CITY OF PLYMOUTH
PLANNING COMMISSION – REGULAR MEETING
WEDNESDAY, MARCH 9, 2016
7:00 P.M.

SP16-01 Pure Barre Plymouth
585 Forest
Zoned: B-2- Central Business District
Applicant: Paul Salloum, Owner

Site Plan Review
For
Plymouth, Michigan

Applicant:	Pure Barre Plymouth 263 Leroy Ferndale, MI 48220
Project Name:	585 Forest – Pure Barre
Plan Date:	February 25, 2016
Location:	585 Forest Ave.
Zoning:	B-2, Central Business District
Action Requested:	Site Plan Approval for Change of Use in Existing Building
Required Information:	Any deficiencies are noted in the report.

585 FOREST AVE
PLYMOUTH, MI
AS-BUILT FLOOR PLAN

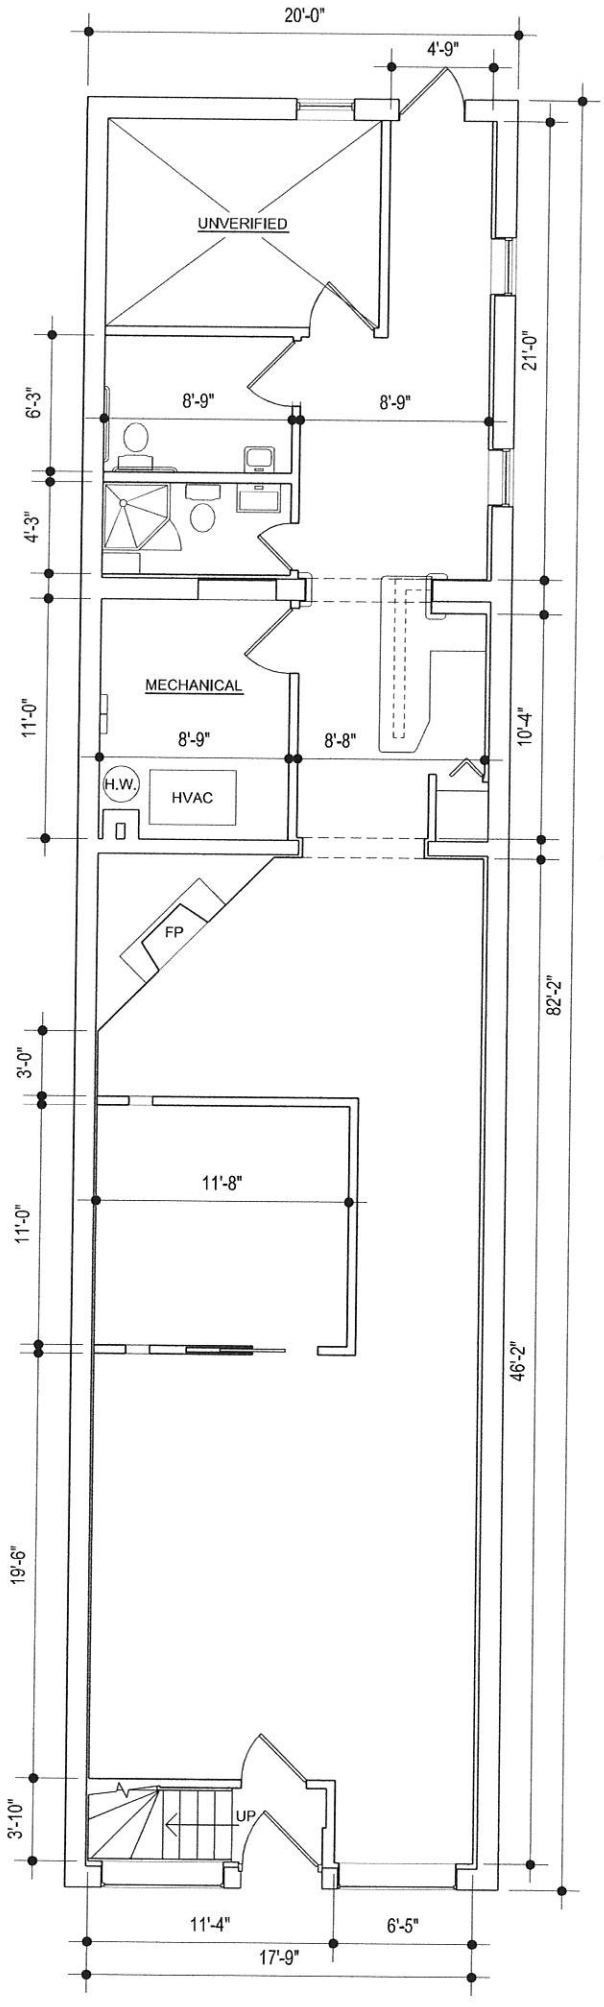
A floor plan of the existing structure has been provided. It appears that interior renovations to raise the ceiling on the first floor are proposed. No changes are proposed to the exterior of the building or the site.

(NOTE TO COMMISSIONERS: EXAMPLE ILLUSTRATIONS TO CHOOSE FROM)

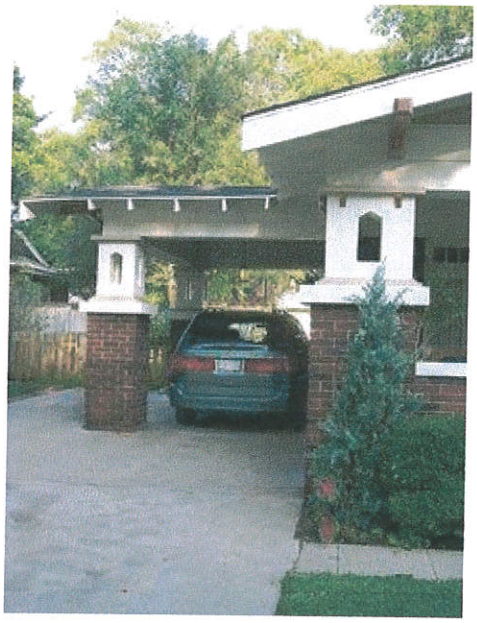
4. Page 3, 4, and 8, for future use of a garage, changing the word future to continued.
5. Change the illustration on page 1, to a shallower roof (to coincide with page 3, C-5).
